Meeting Room 106 A/V System Concerns

(Section 16600, part 2.5, Pages 786-787)

September 30, 2022

The following errors, omissions and inconsistencies have been identified by the library staff:

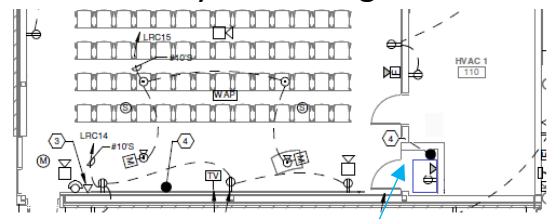
- 1. Location of rack.** Current blueprints call for the rack to be installed in the meeting space itself in the corner closest to the HVAC room by the podium. Ideally, it would be better if the rack were located in a closet carved into the HVAC room with a locked door and louvers at the door bottom for ventilation. Having equipment in a closet instead of a rack in the open will allow for microphones, mic stands and cords, as well as hearing-impaired and other equipment to be neatly stored together.

Existing location of A/V rack
(bolted to the corner wall at eye level)

New location of A/V rack
(inside a closet with vented door).

- 2. Non-Metal enclosed rack.** The current rack mentioned on page 787 is an Atlas/Soundolier Series 340-21B wall rack bolted to the wall. It is completely enclosed in metal with a metal locked door. The plans also call for a wireless microphone system (B.5 on page 786) and a hearing-impaired wireless system (B.12 on page 787). Both of these use antennas for transmission and reception.

Keeping these antennas in a metal enclosure creates what is known as a “Maxwell cage” effect, where radio signals are partially or completely blocked. This problem can be eliminated if we located the rack inside a locked closet as mentioned in #1 above. The rack then can be open on all sides since the closet drywall and wood will pass radio signals. Whatever rack is used, it will need to support at least 16U of equipment. *(Suggested Vevor 18U open rack is pictured on left.)*
